Agenda Item 3

590 Sheridan Road

Rear Porch Addition, Exterior Alterations and Building Scale Variance

STAFF REPORT AND RECOMMENDATION

EXISTING BARNHOUSE - South Elevation

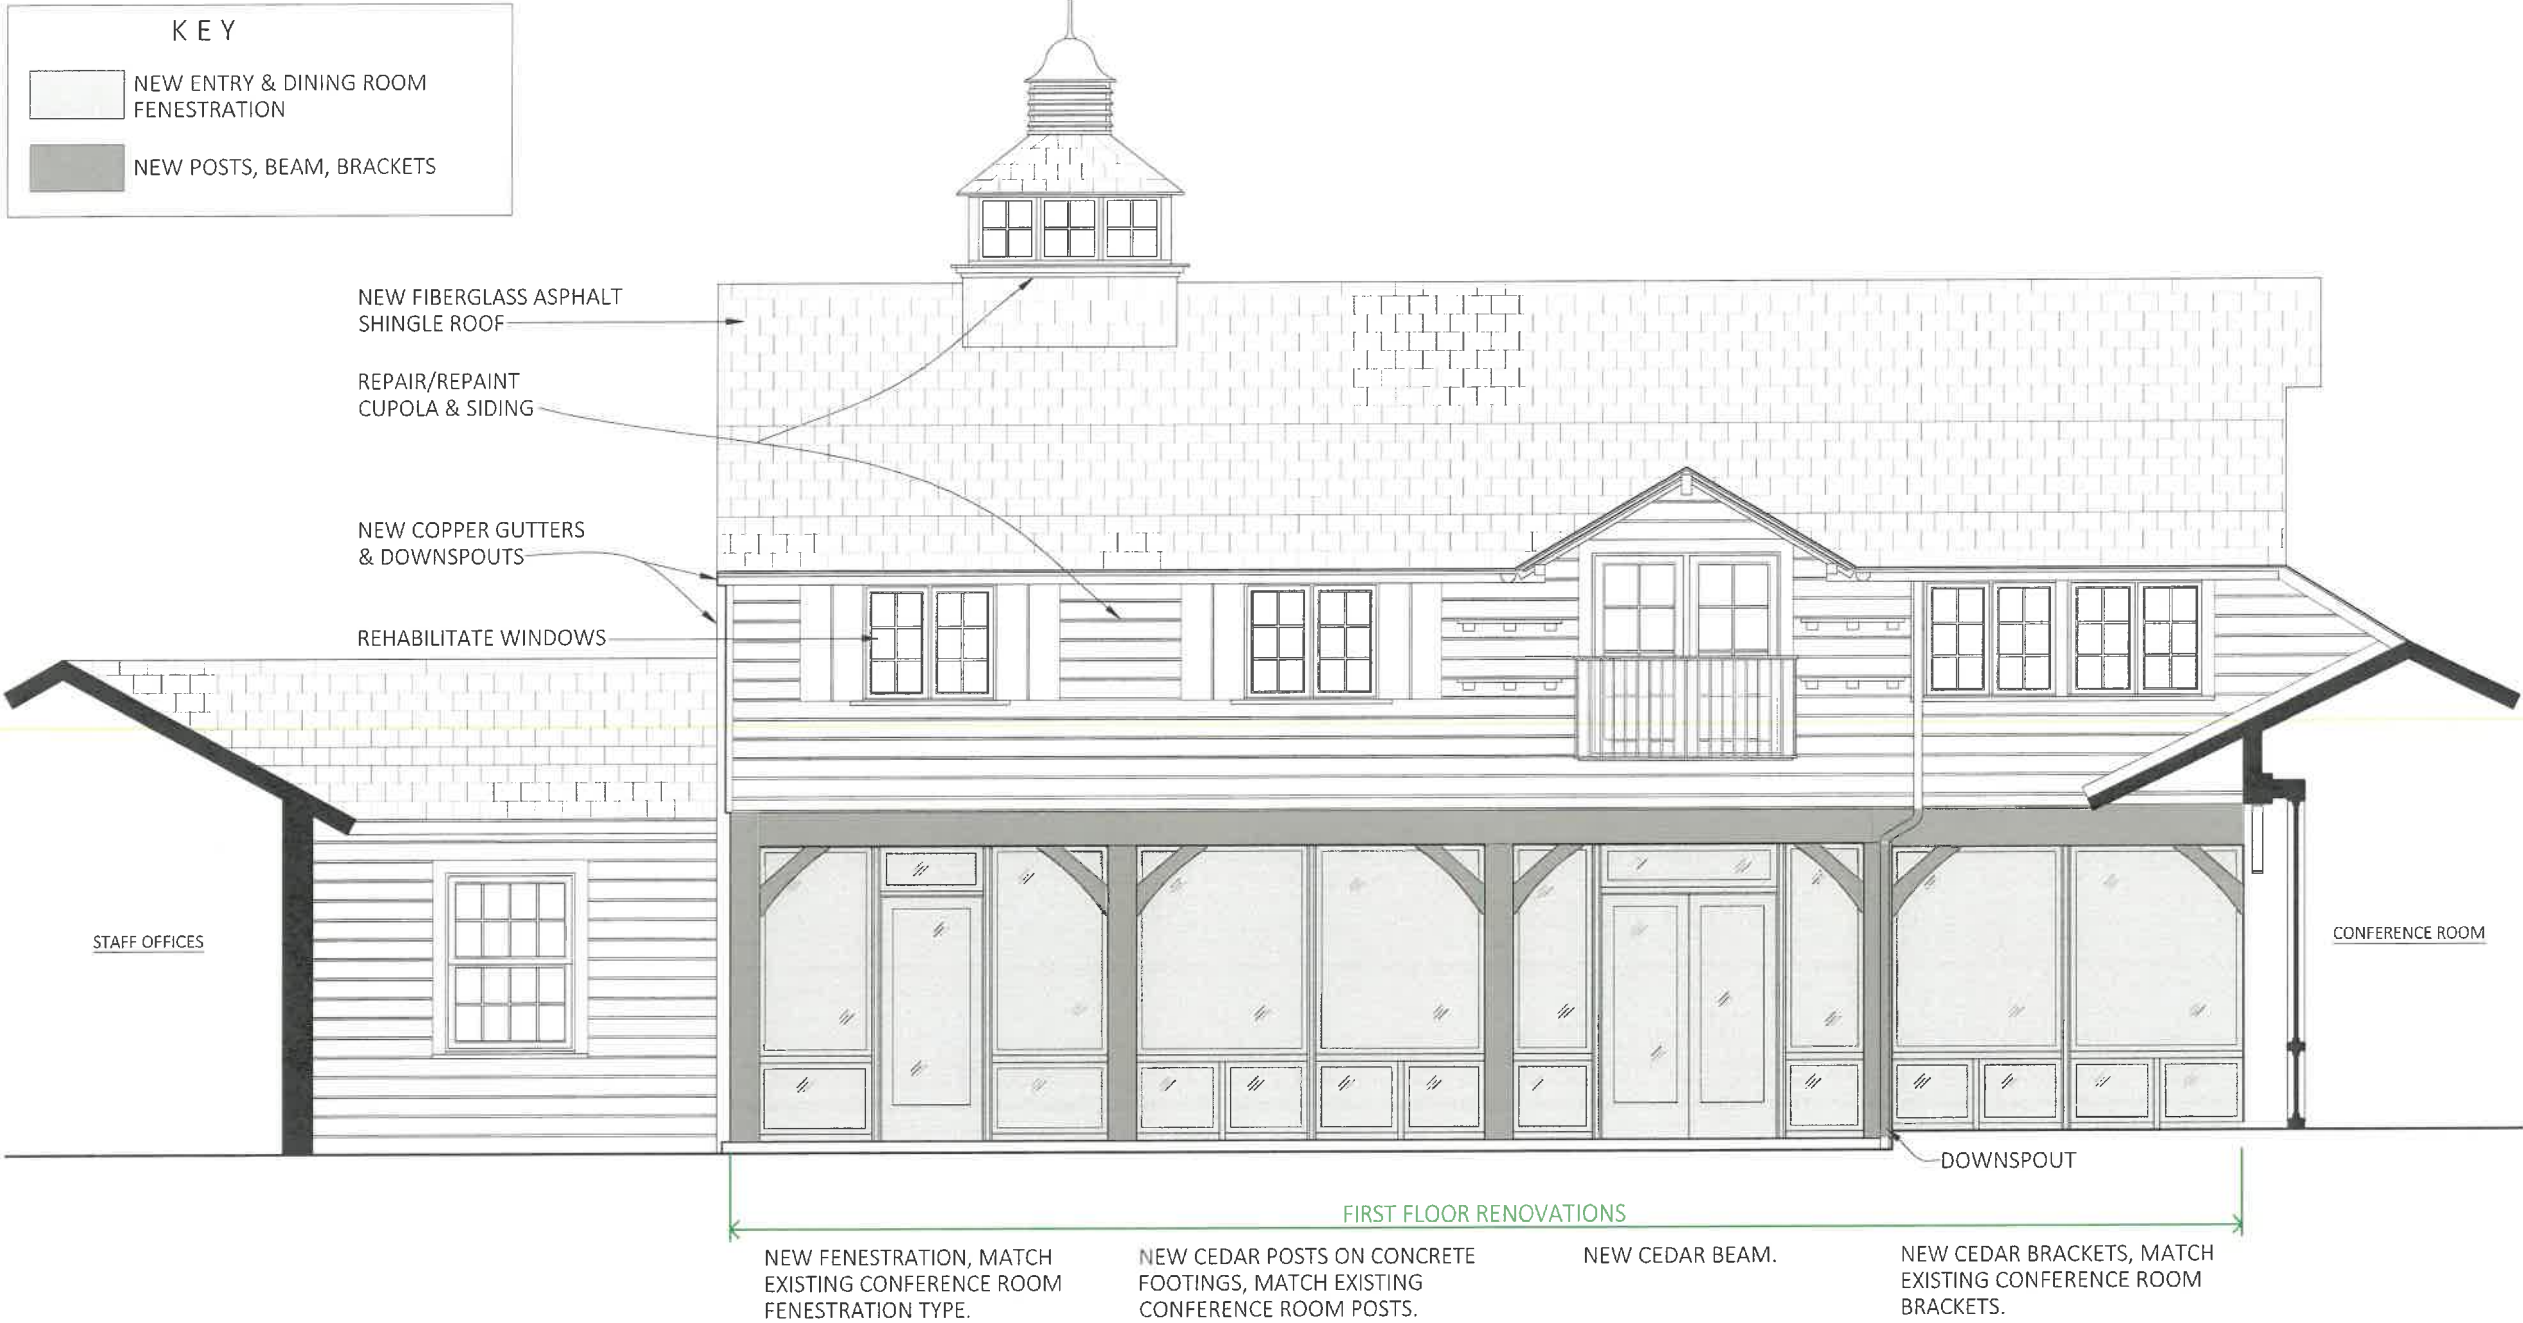
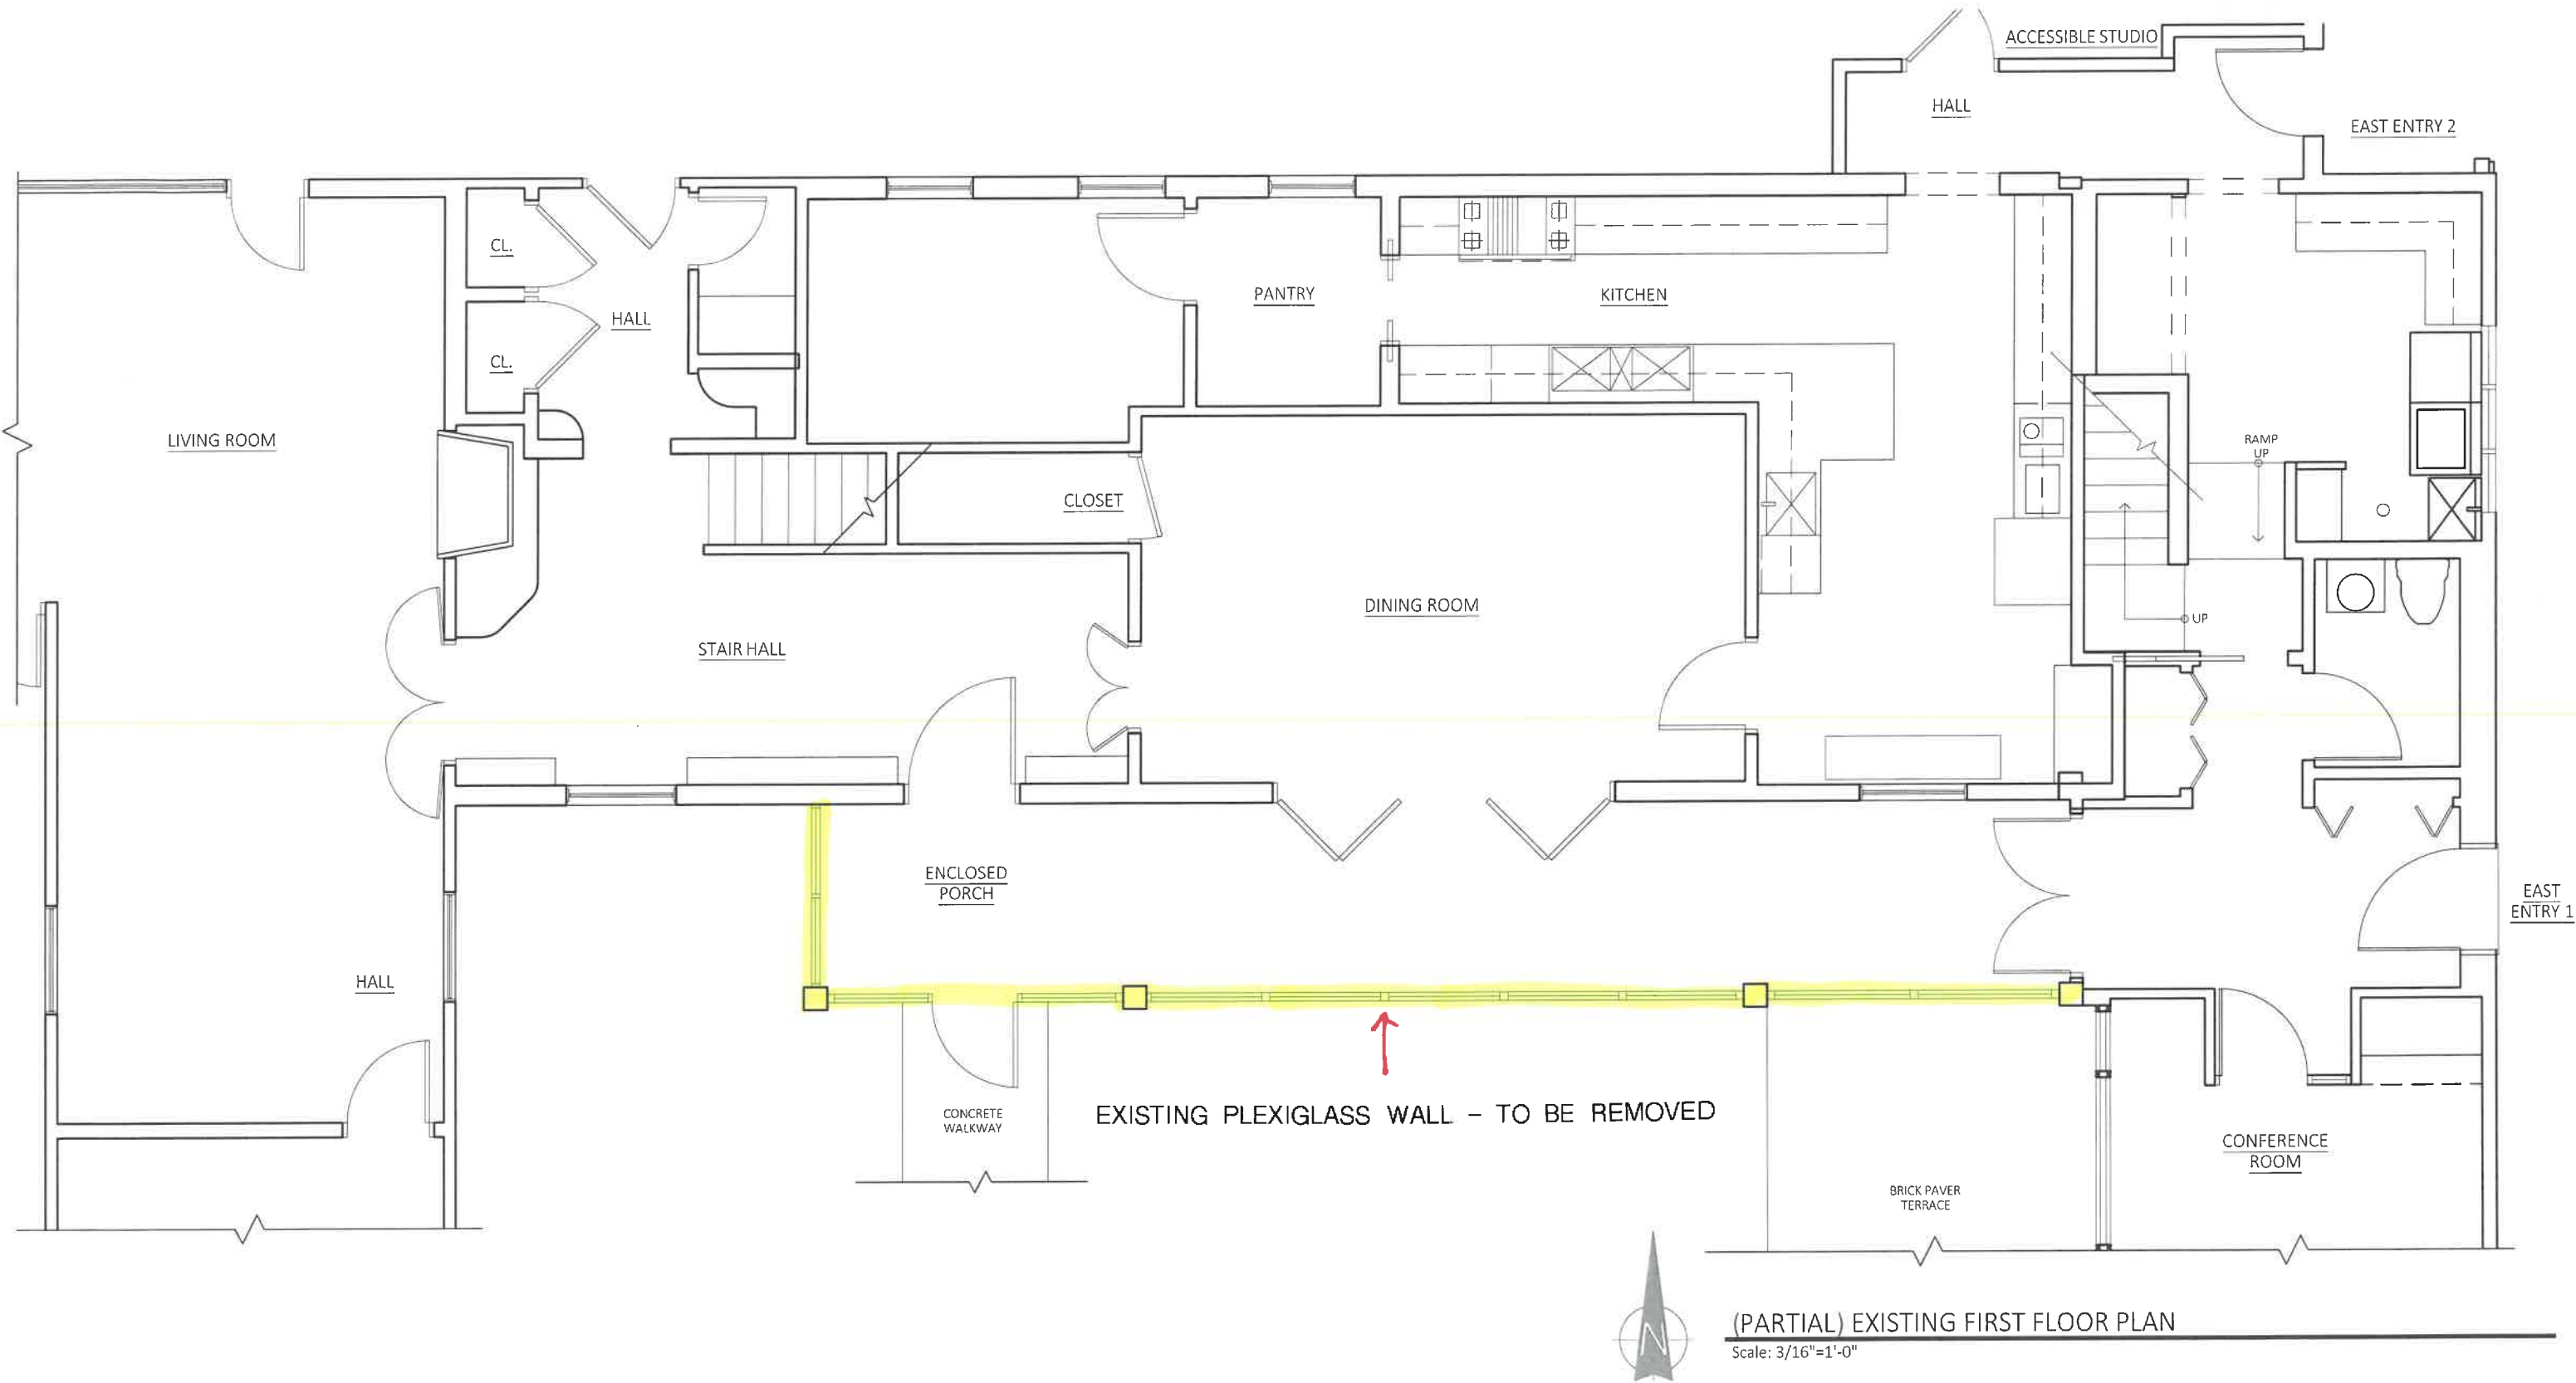
We will re-instate the brackets at the first floor exterior posts, restoring the original barn façade configuration (see historic photos). Brackets will be similar to the Conference Room, in cedar rather than painted wood. This is a logical continuation of the 2004 Conference Room façade rehabilitation. With the planned Barnhouse changes, there will be a consistent look on both the north and east building wings facing the courtyard.

- Barnhouse exterior- remove first floor porch window wall and provide new to match the adjacent conference room wall. For the balance of the windows in this building, rehabilitate and provide new screens/storm windows as required.
- Conference room wing – existing windows to remain.
- Accessible first floor studio – existing windows to remain.

- The existing first floor porch window wall is carpenter built, 2x4 framing with uninsulated glass panels. It has no historic significance nor would we want to replicate its substandard construction. Therefore, it will not be repaired or replaced in-kind.
- First floor porch post brackets will be made of rough sawn cedar, sized and configured per historic photos.
- The existing roof is an asphalt shingle replacement roof, and therefore its removal and replacement is not significant to this Standard.
- Existing gutters and downspouts are painted metal. We intend to replace them with copper material to match the Conference Room.
- Windows: All window restoration/rehabilitation efforts will be made to meet Secretary of the Interior Standards for the Treatment of Historic Properties.
